PROPOSED SITE PLAN

PROPOSED CONVERSION OF OFFICE BUILDING TO APARTMENTS, SPRINGFIELD HOUSE, BARNSELY

CLIENT: EMPIRE PROPERTY CONCEPTS
DWG NO: K838/01
SCALE: 1/200 @ A1
DRAWN BY: D.D.
DATE: 08/01/18
REV: A

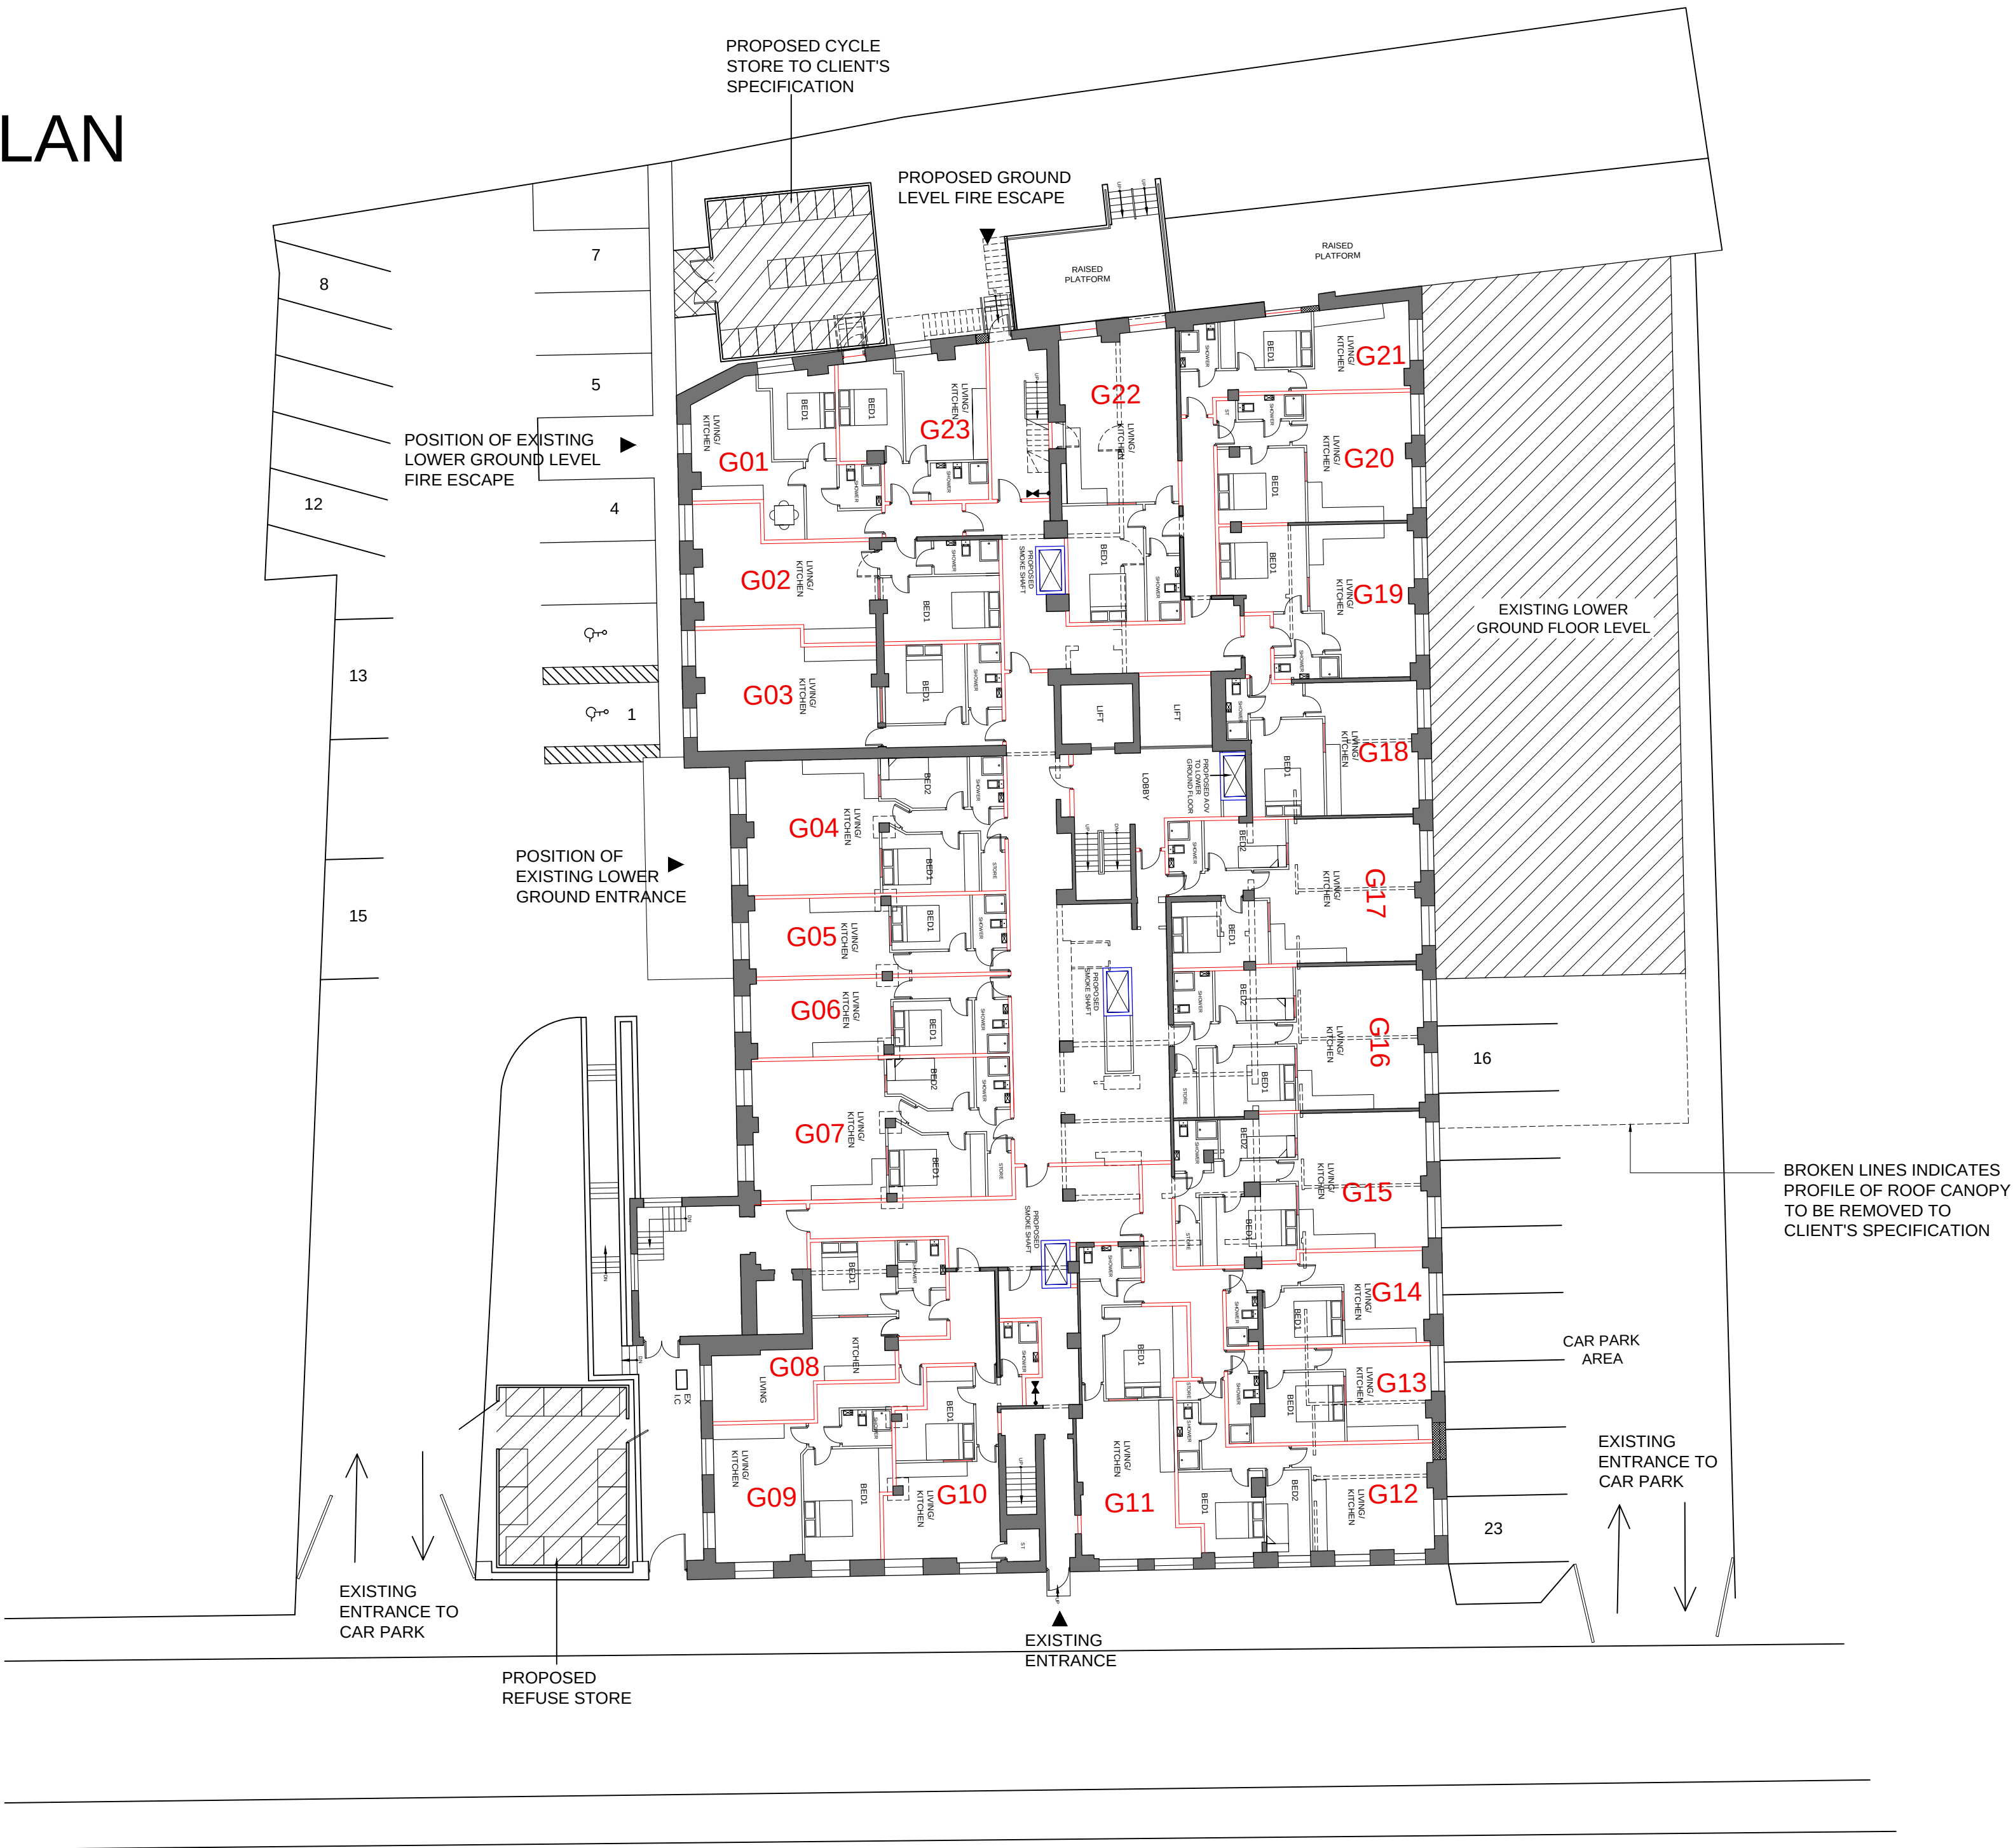
REV	DESCRIPTION
A	VENTILATED LOBBIES, SMOKE SHAFTS, CORRIDOR WALL ADDED AND APARTMENT LAYOUT REVISED REVISED TO FIRE OFFICER'S COMMENTS 11.04.18 D.D.
